SAN ANTONIO WATER SYSTEM
University Pump Station Improvements Project
SAWS Job No. 12-6002
Solicitation No. B-14-053-DD

ADDENDUM NO. 2

July 30, 2014

**CONTROL VALVE REPLACEMENT
PLAN AND SECTION**

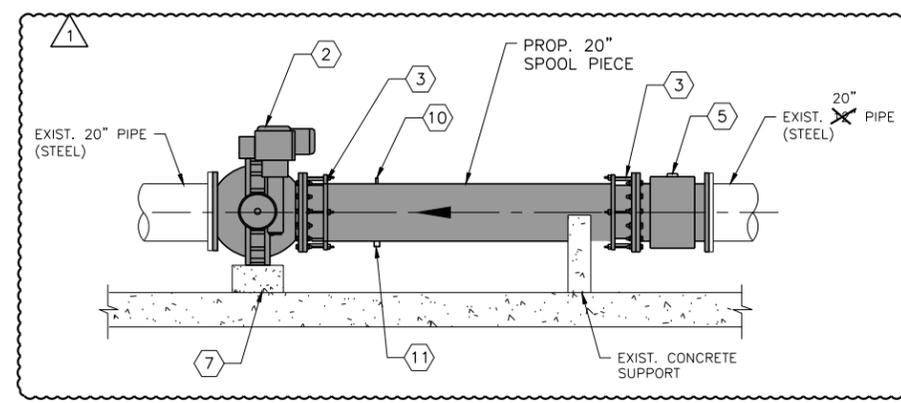
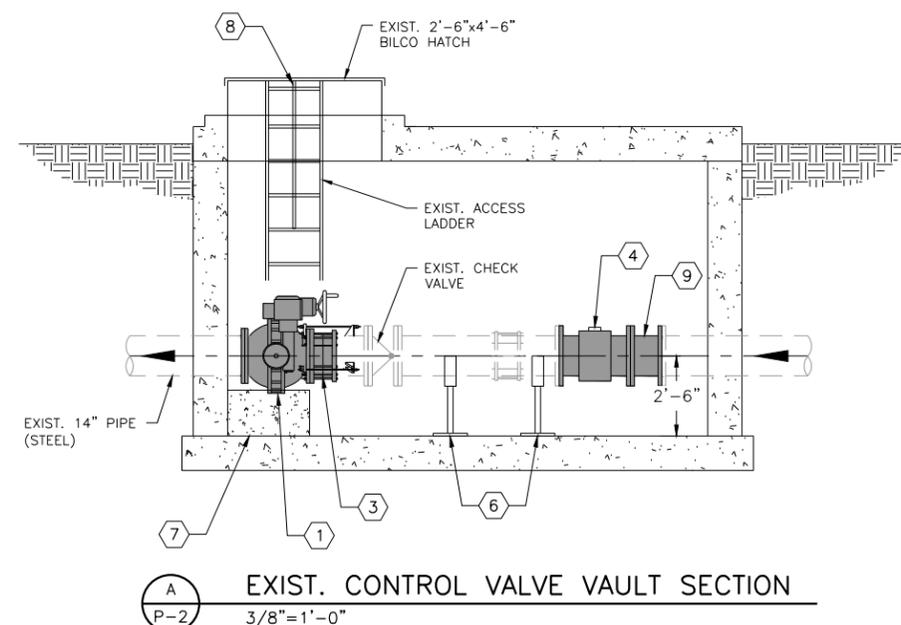
2. SHEET P-2, CONTROL VALVE REPLACEMENT PLAN AND SECTION:

A. REPLACE drawing in its entirety with the attached sheet.
